# CITY OF ALBUQUERQUE

## INTER-OFFICE MEMORANDUM

**SUBJECT:** AC-23-9, PR-2021-006366, VA-2023-00021, BP-2022-30010:

Peggy Norton, on behalf of the North Valley Coalition, appeals the Site Plan-Administrative decision to approve a Site Plan for all or a portion of LOT 1, TRACT 112-A-2 BLOCK 2, Douglas MacArthur Subdivision zoned MX-M, located at 5307 4<sup>th</sup> Street, NW containing approximately 1.4319 acre(s). (F-14)

Figure 1. Excerpt of the February 2022 approved plat (yellow highlight indicated information on sidewalks). Full Plat application is in the Record of this appeal.

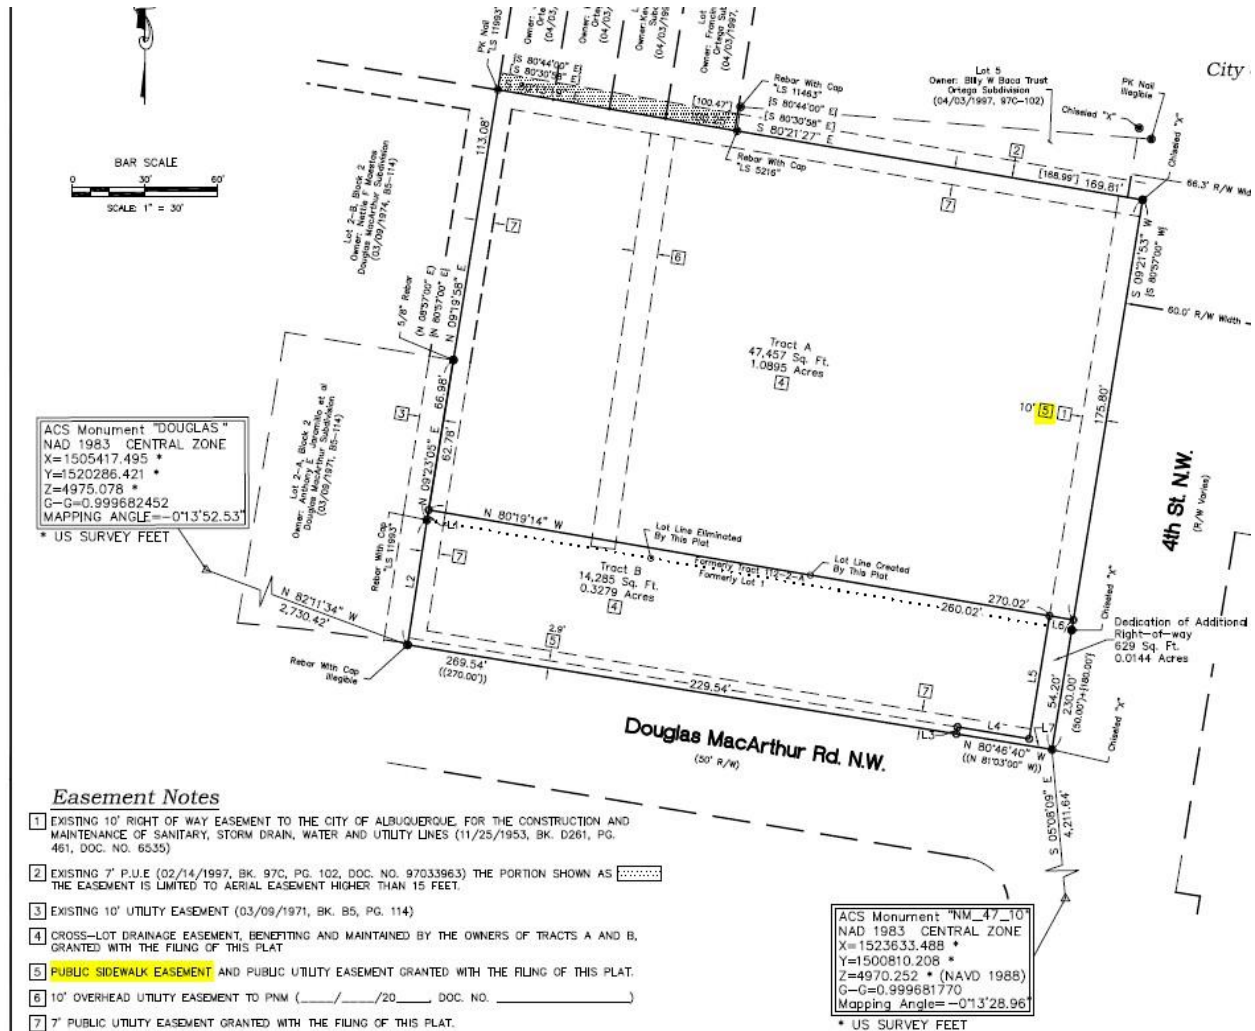
Preliminary Final Plat. On February 16, 2022, the Development Review Board (DRB) reviewed and approved a request for a replat of the property for the car wash. Transportation comments from the January 6, 2021 Sketch Plat thru the February 16<sup>th</sup> approval were to provide a 10-foot sidewalk on 4<sup>th</sup> Street because it was a Main Street and a 5-foot sidewalk on Douglas MacArthur. There was no discussion of a landscape buffer in either Transportation or Planning Comments.

1. **Appellant:** The Planning staff acted arbitrarily and capriciously by not complying with the street element dimensions as stated in CPO-9 of the IDO and the Development Process Manual. Staff did not consider precedent or take prior knowledge into decision-making regarding the 4<sup>th</sup> Street element dimensions.

2. **Appellant:** The decision was not supported by substantial evidence. No policy citations were offered during the facilitated meeting to justify the sidewalk width. The appellant did not have access to the file to evaluate substantial evidence.

**Staff Response:** The Site Plan review happened after a plat had been established. In the Plat review, the Development Review Board approved a Preliminary/Final Plat that established a 10-foot sidewalk adjacent to the curb that was compliant with the DPM. The applicant built the sidewalk per the approved plat and associated infrastructure list.

**Staff Response:** The sidewalks for 4<sup>th</sup> Street and Douglas MacArthur do match the desired widths outlined in DPM Table 7.2.29. The 4<sup>th</sup> Street sidewalk appears to have been built at 10 feet and Douglas MacArthur at 5 feet. The text of Table 7.2.29 states that the table does not indicate a requirement and should be used on combination with Comprehensive Plan Table 7-5. The appellant's concern seems to be more focused on the sidewalk being attached to the curb. That decision was made previously when the project was in a DRB plat process and the applicant had an infrastructure list approved.

The Planning staff reviewed the application for a site plan-administrative and found that it met the requirements of the IDO and DPM. The width and location of the sidewalk were previously decided by the DRB on February 16, 2022 in its approval of the Preliminary/Final Plat. The Planning staff reviewed the site plan application according to the IDO and DPM and found that they were compliant. The staff determined that the sidewalk improvements and the landscaping plan, showing that there would be landscaping on the 'inside' of the sidewalk, met the balancing test prescribed in the DPM and Comprehensive Plan. The decision was supported by substantial evidence and was not arbitrary or capricious. The Planning staff did not err in applying the IDO and DPM to the site plan.
